PHILCO RADIO-PHONOGRAPH MODEL 51-1330

MODEL 51-1330
IF 455 KC

Run 2 I-F Transformer

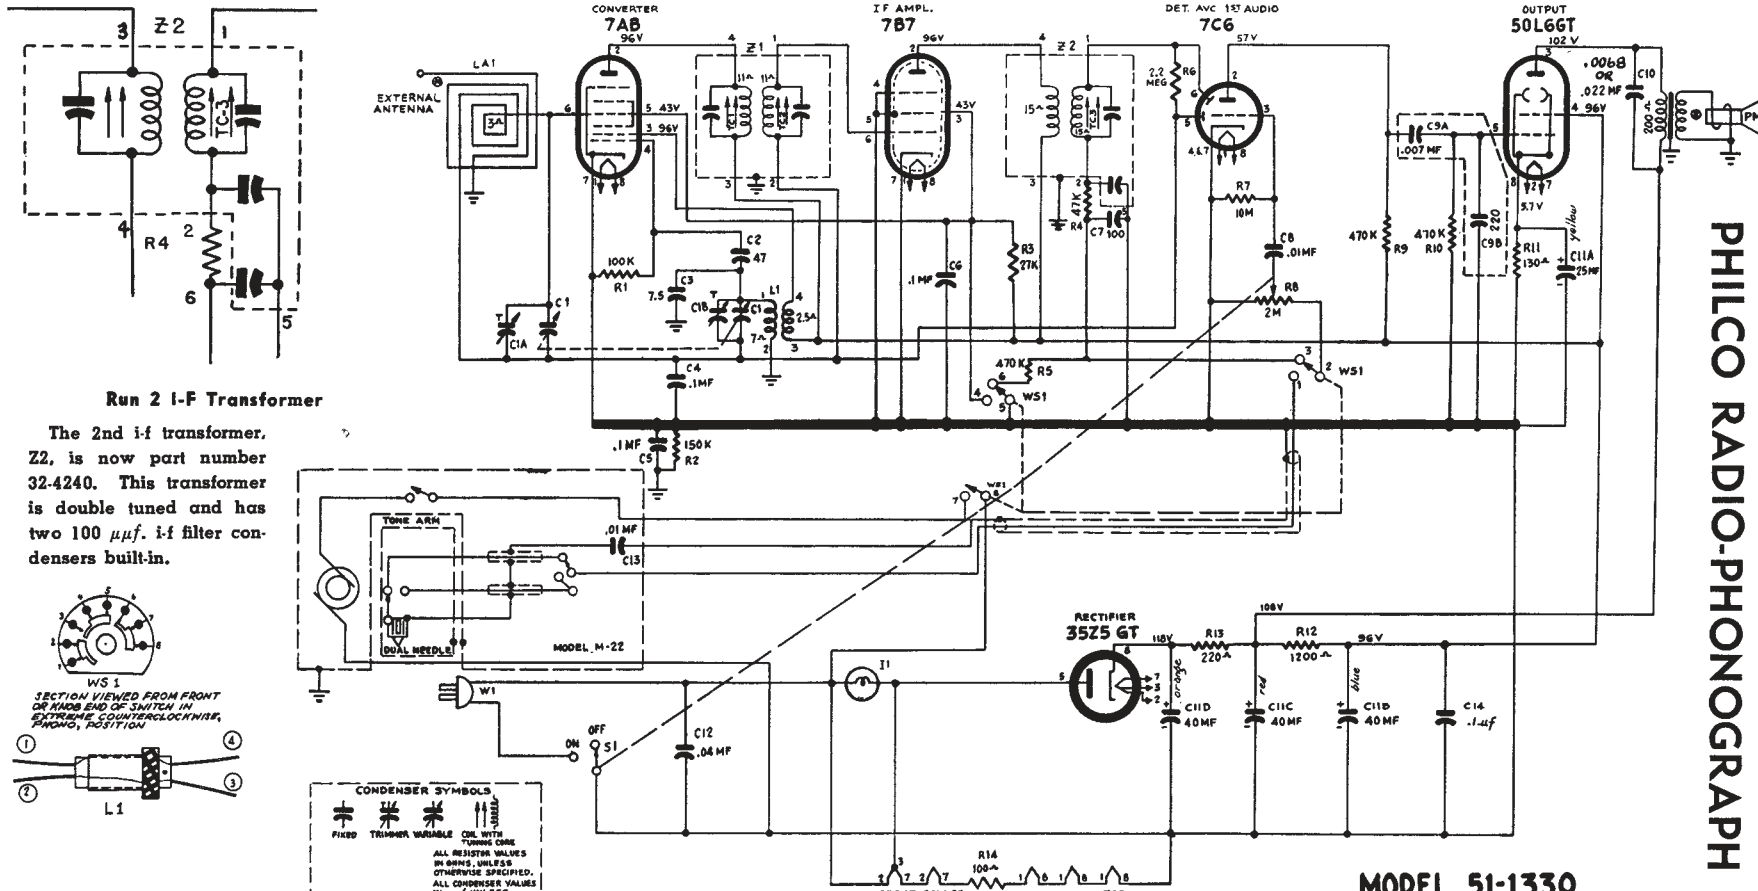
The 2nd i-f transformer, Z2, is now part number 32-4240. This transformer is double tuned and has two 100 μ f. i-f filter condensers built-in.
